The Commission has issued the enclosed Amendment No. 87 to Facility Operating License No. DPR-58 and Amendment No. 73 to Facility Operating License No. DPR-74 for the Donald C. Cook Nuclear Plant, Unit Nos. 1 and 2. The amendments consist of changes to the Technical Specifications in response to your application transmitted by letter dated December 17, 1984, as supplemented by letter dated June 4, 1985.

These amendments revise the Technical Specification that update the offsite organization chart, organization and responsibilities of the Plant Nuclear Safety Review Committee (PNSRC) and Nuclear Safety and Design Review Committee (NSDRC), to update the reporting requirements addressed by the recent revision to 10 CFR 50.73, to revise the containment isolation valve listing, correct battery electrolyte surveillance temperature, and make a number of editorial changes.

Donald C. Cook Nuclear Plant

SAFETY EVALUATION BY THE OFFICE OF NUCLEAR REACTOR REGULATION
RELATED TO AMENDMENT NO. 87 TO FACILITY OPERATING LICENSE NO. DPR-58
AND AMENDMENT NO. 73 TO FACILITY OPERATING LICENSE NO. DPR-74
INDIANA AND MICHIGAN ELECTRIC COMPANY
DONALD C. COOK NUCLEAR PLANT UNIT NOS. 1 AND 2
DOCKET NOS.

FIGURE 6.2-1
 ORGANIZATIONAL RELATIONSHIPS WITHIN
 THE AMERICAN ELECTRIC POWER SYSTEM
 PERTAINING TO QA & QC AND SUPPORT OF THE
 DONALD C. COOK NUCLEAR PLANT

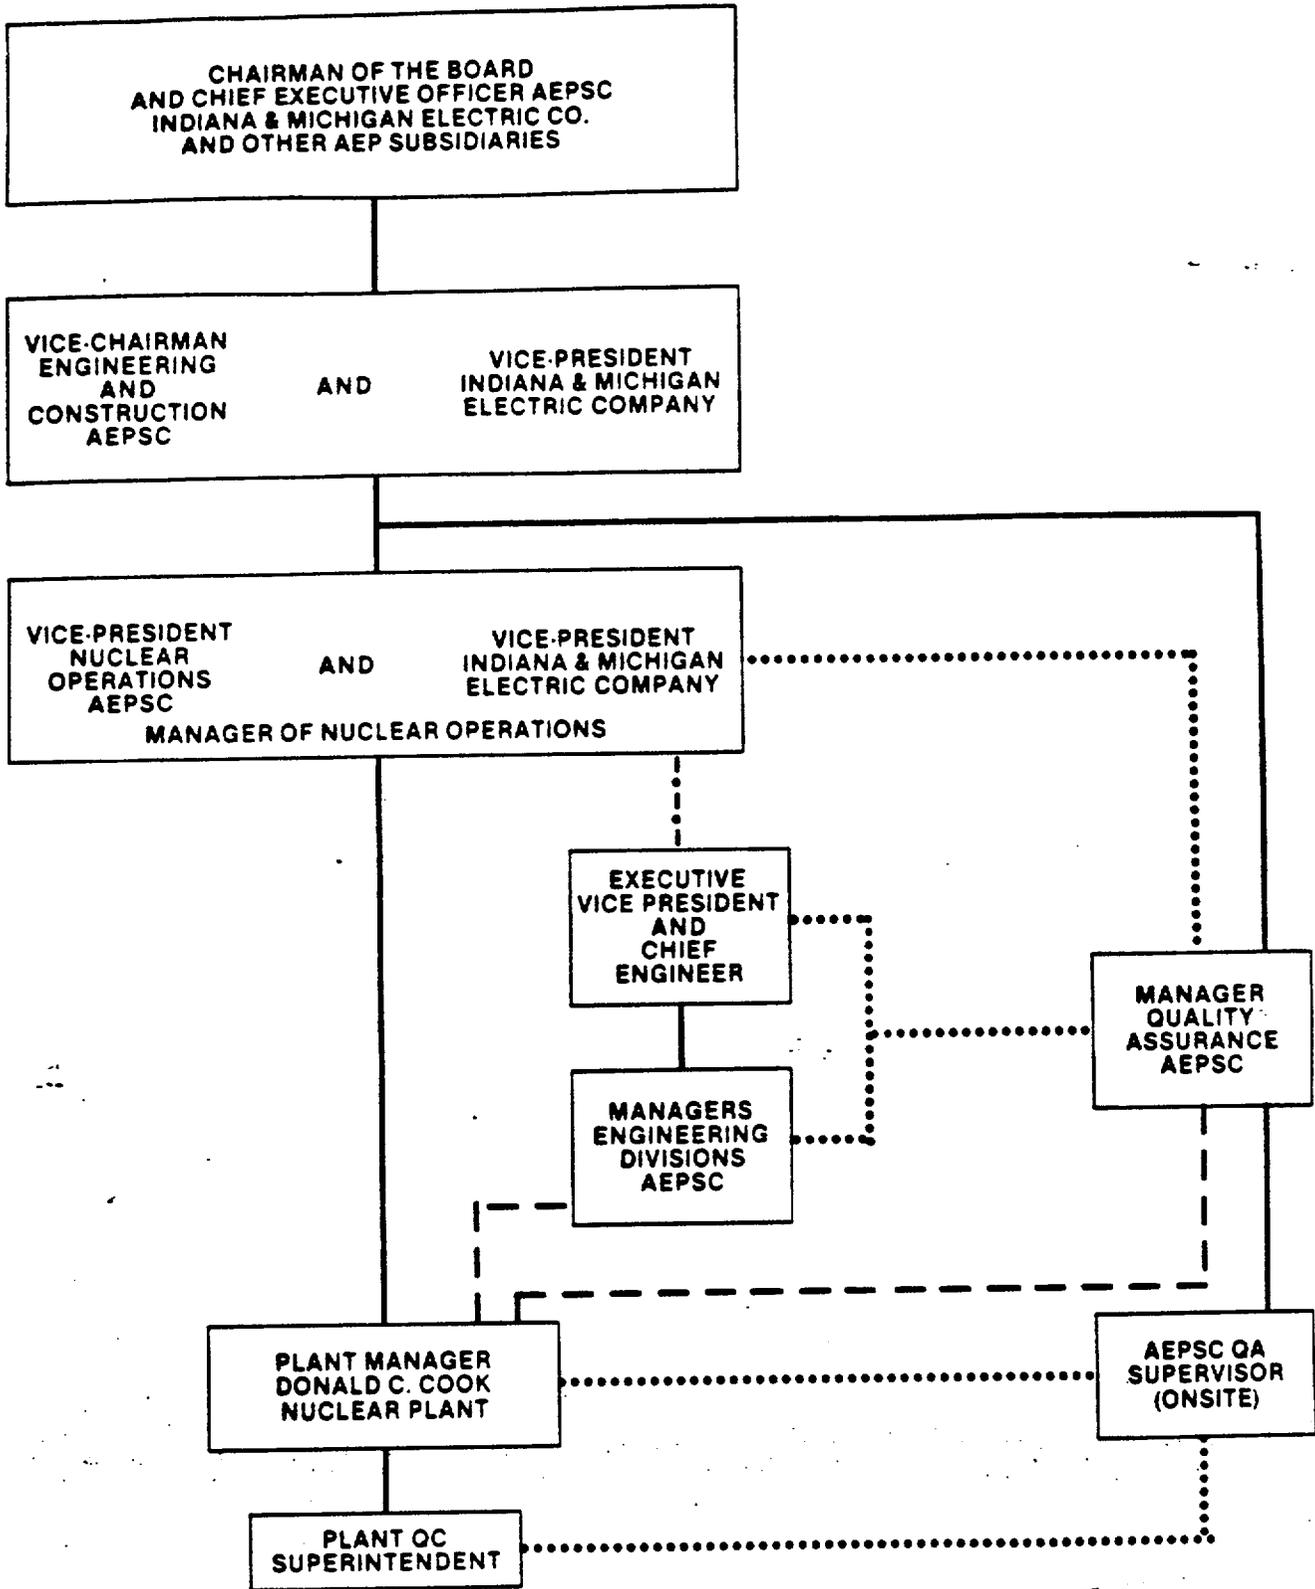
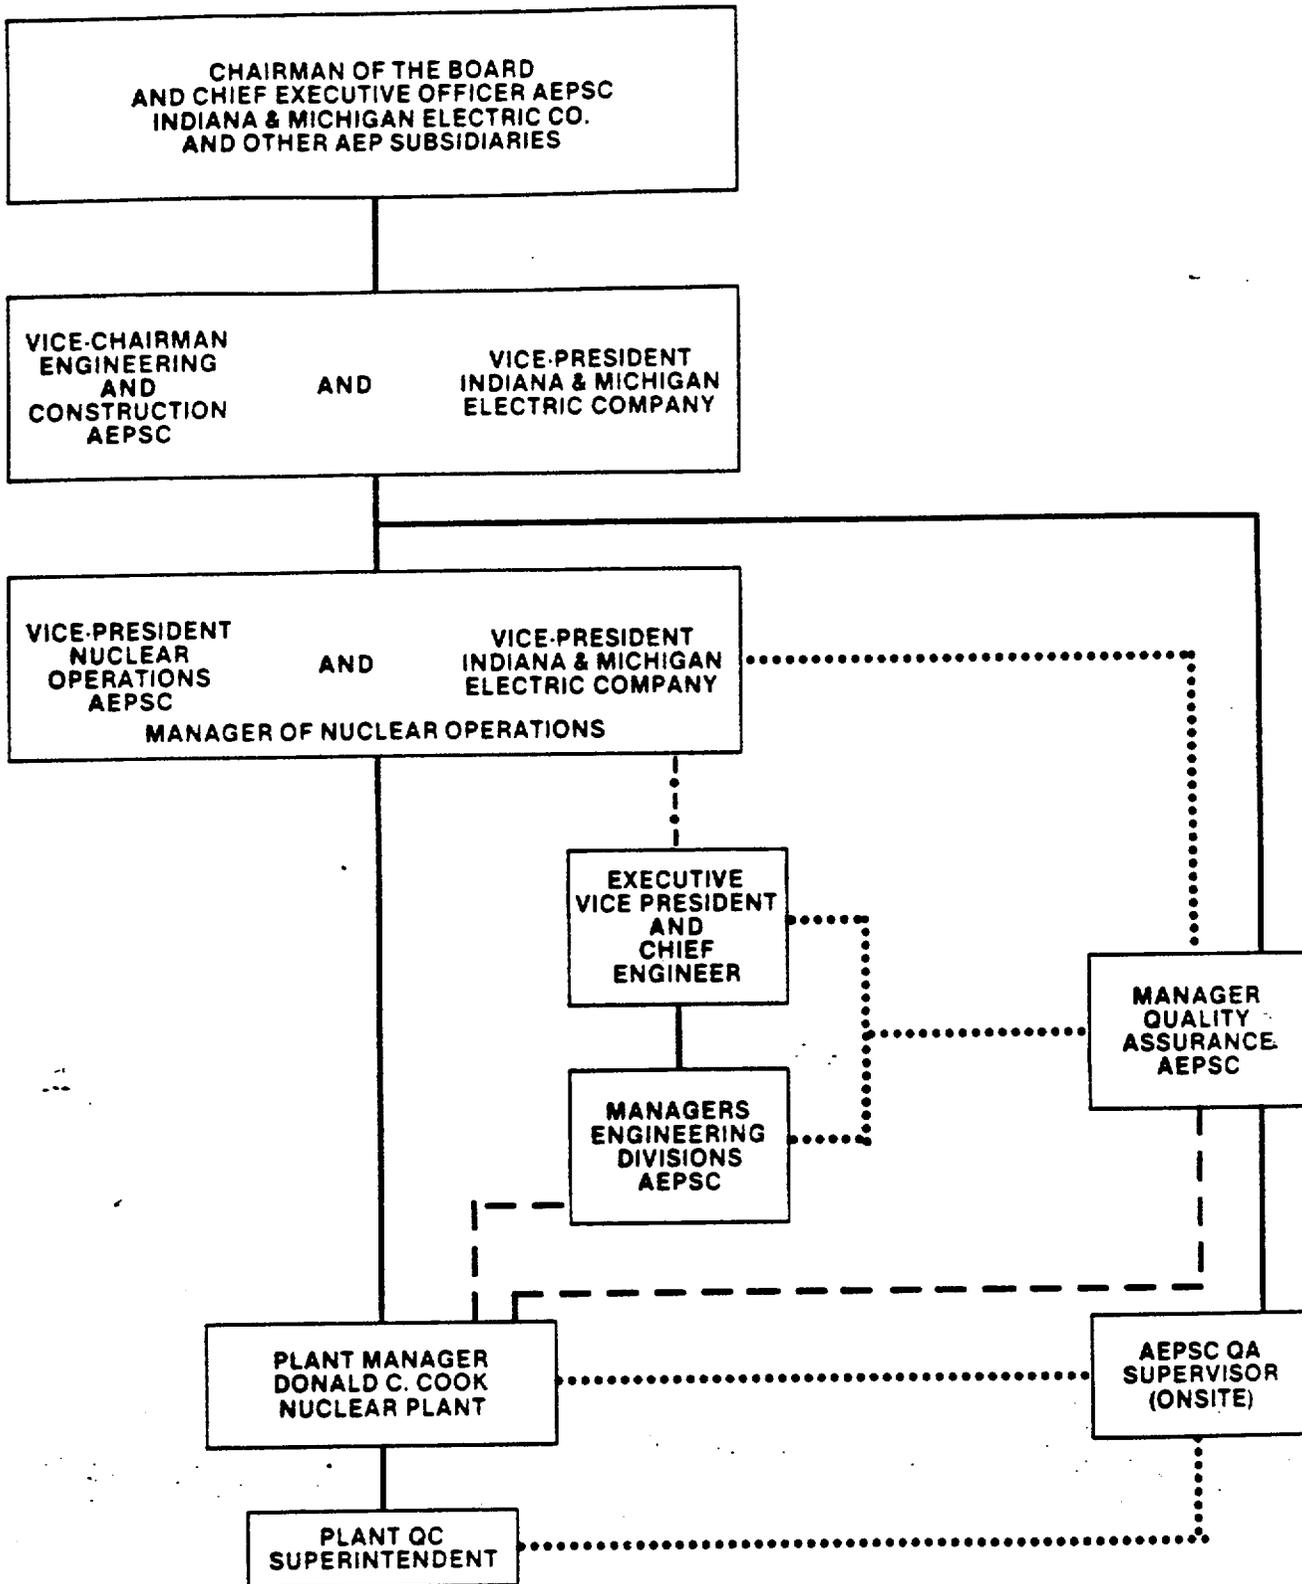
1. Figure 6.2-1 (Offsite Organization Chart) for Units 1 and 2 is changed to reflect the reorganization that occurred as a result of the quality assurance enhancements that were made pursuant to NRC recommendations and as a result of the corporate move to Columbus, Ohio. These changes are acceptable as they do not diminish the level of corporate support to the nuclear plant.

6.2.1 The offsite organization for facility management and technical support shall be as shown on Figure 6.2-1.

6.2.1 The offsite organization for facility management and technical support shall be as shown in Figure 6.2-1.
